(Original: October 28, 2006)
Rev. November 2, 2006

To: Distribution
From: GDE Change Control Board
**Subject: Response to the Change Request (October 7, 2006) for the BCD
Parameter/Layout Section – CCR#18**

Figure 1: (a) Schematic view of the ILC baseline layout for phase-1; (b) Scaled 3-D schematic view on one side of the damping ring injection/extraction; (c) A possible layout topology of conventional facilities for the area shown in (b).

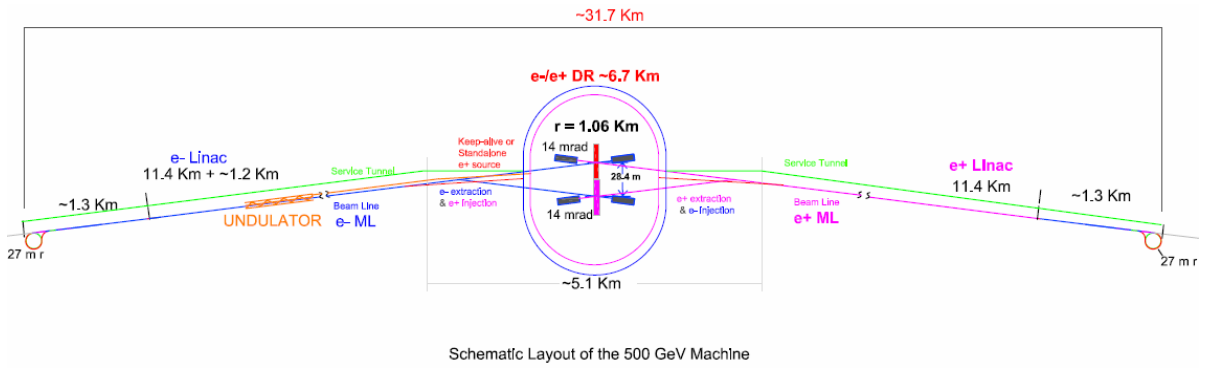
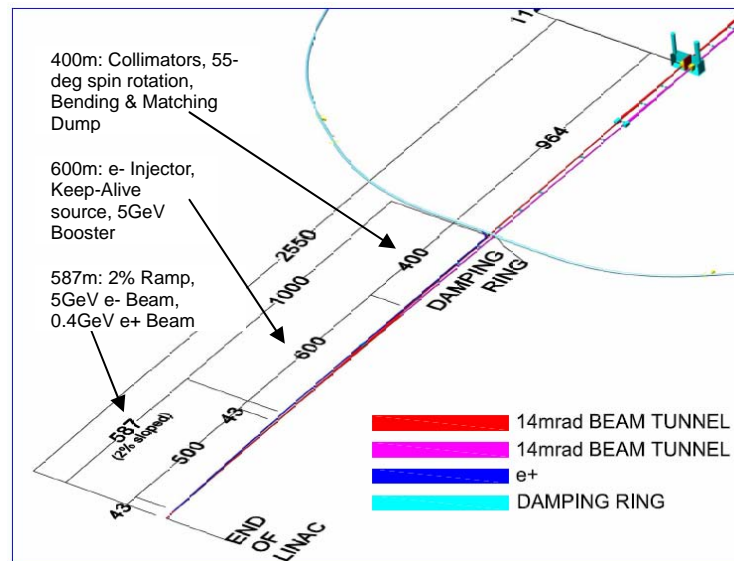
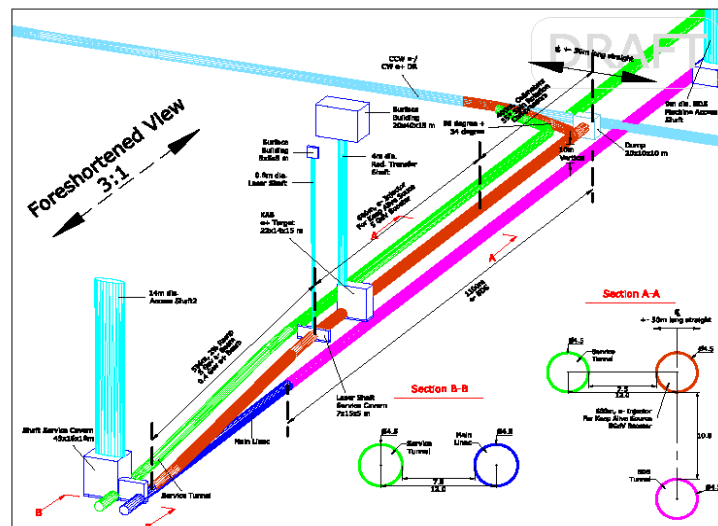
- CCB feels that in this section of BCD some refinements of illustrations for the layout are worth for helping the readers. The beam paths as a result of this CCR would become substantially more complex than before. Some textual description of other parts of the BCD, in particular in relation to the path length constraints stemming from bunch timing considerations, will be also helpful. A suggested replacement text, which supersedes the version submitted by the requesters, is attached as Appendix A.

Figure 1(a) shows a schematic view of the baseline layout for ILC in its phase-1 configuration which supports physics experiments at center-of-mass energies up to 500 GeV. The site footprint is dominated by two main linacs, for accelerating electrons and positrons, respectively, each of which extends over a length of approximately 10 km. Together with the electron sources, damping rings and the beam delivery systems, the total site length is expected to be approximately 31 km.

Figure 1(b) shows a scaled, closed-up view in a 3-dimensional perspective which focused on the positron injection and electron extraction from the damping ring complex.

Figure 1(c) gives a possible layout of the conventional facilities which correspond to the beam lines shown in Figure 1(b), for illustration purposes. Details of the exact topologies are subject to changes through further engineering design efforts.
